# WF85 - Performing Measures for Ensuring the Quality of Vehicles During Delivery to Customers (Stop Sale Campaign/Workshop Campaign)

Revision: **December 15, 2017**

This revision amends campaign bulletin Group 0, #94/16, dated November 28, 2017.

Vehicle Type: Cayenne Diesel (92A)

Figure 1

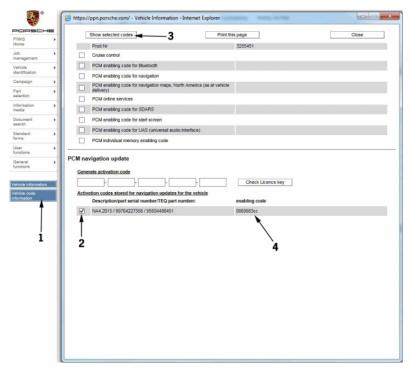
- Screen shot "Figure 1" was added to Remedial Action Step 2.

To generate the enabling code for the use of the navigation database DVD, Part # 99764227358 go to the PCM navigation update section of Vehicle code information & click in the box next to the navigation map update (See Figure 1 #2) and hit the button "show selected codes" (See Figure 1 #3). The enabling code (See Figure 1 #4) will then be displayed next to the navigation map update."
